# Intel<sup>®</sup> Ethernet Controller I210

Specification Update

*November 2020*

Revision 2.9  
332763-013

**Figure 1-1. Explanation of Top Markings for A3 Stepping**

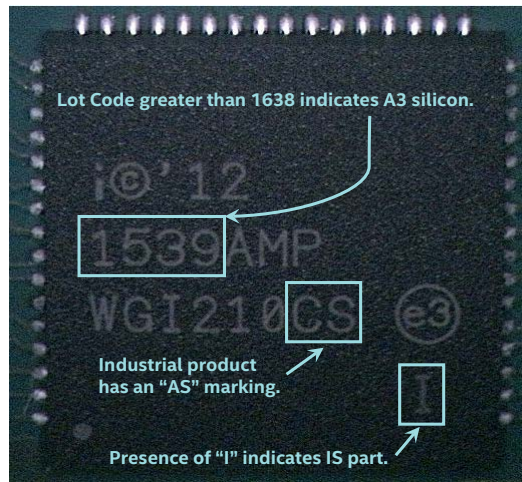
The A3 stepping only applies to the Fiber (IS/CS/CL) products. The A3 stepping can be identified by the Fab Lot Trace Code marking on the package or by the iNVM contents.

- Fab Lot Trace Codes starting with 1638 or greater are A3 devices.
- Bit 1 of INVM\_DATA[61] (0x12214) is 1b on A3 devices.
